Safety Defect and Noncompliance Report Guide for Equipment
PART 573 Defect and Noncompliance Report

Generic name of the item: Rear of Car Bike Rack System

Model: SpareTime

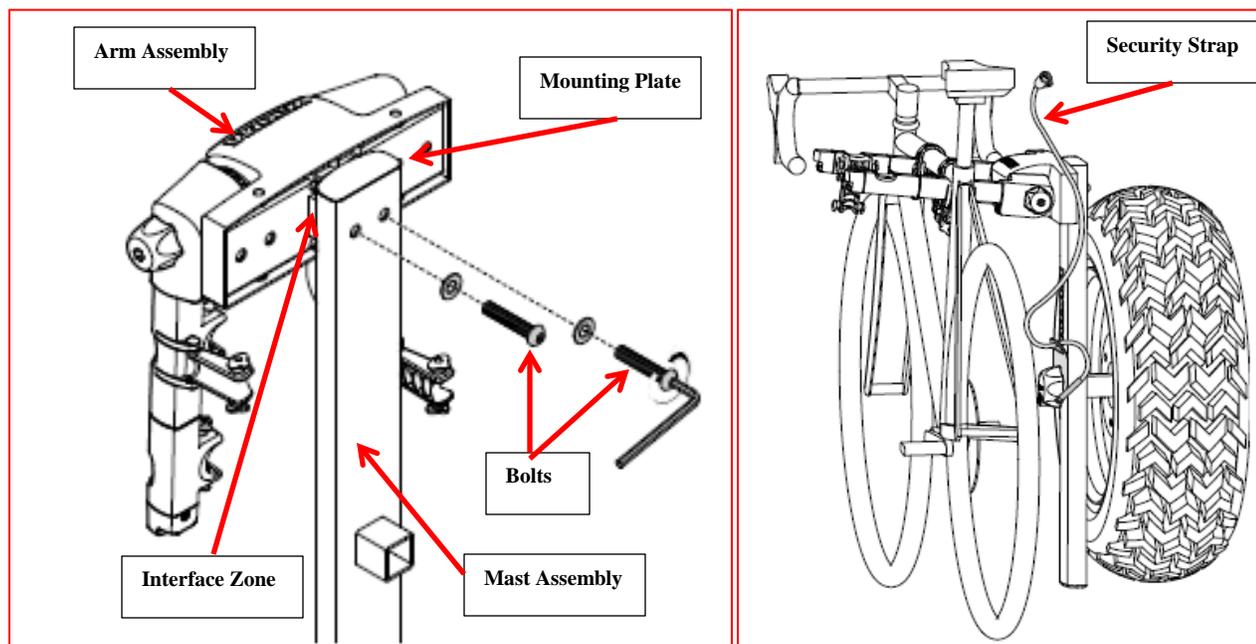
The equipment impacted attaches to spare tire mounting bolts on the rear of a vehicle in applications similar to the one pictured above. When viewed from the back side of the product (i.e., the side facing the rear of the vehicle) there is a silver looking mounting plate containing six threaded inserts used to attach the arm assembly to the mast assembly. These bolts allow for positioning the arm assembly in a right, center or left orientation depending on the position of the spare tire holder on the applicable vehicle. Any SpareTime product containing bolts that are not identified with a head marking (See “Bad Bolt” picture below), need to be replaced with a one that has markings (See “Good Bolt” picture below).

Based on consumer reports (two) and actual testing conducted by Yakima, the strength of material used to manufacture the bolts did not meet the requirements for an M12X1.75X65 MM, Button Head Bolt per ISO 7380 Grade 10.9. As a result, the bolts have been seen to break between the interface zone between the face of the mast and the back of the mount plate

The cause for the defect is due to the bolt material being too soft (32 to 39 Rockwell C). Test bolts were far below the requirement indicated and a lower quality material was used to manufacture them. When tested, the bolts did not exhibit the necessary tensile strength or hardness that correlates to M12X1.75X65 MM, Button Head Bolt per ISO 7380 Grade 10.9. When a soft bolt is used in the SpareTime application, product motion induced by terrain and vehicle speed eventually causes them to crack.

Remedy: As directed in the Consumer Letter to be issued concurrent with this report, owners of suspect SpareTime products can contact Yakima to obtain replacement bolts to be sent to them via mail. The bolt application in the product is designed to be consumer serviceable. The consumer will be sent two bolts inside a bubble line manila envelope with brief instructions on what to do when they receive it. Until the consumer receives and installs the replacement bolts, the product should not be used.
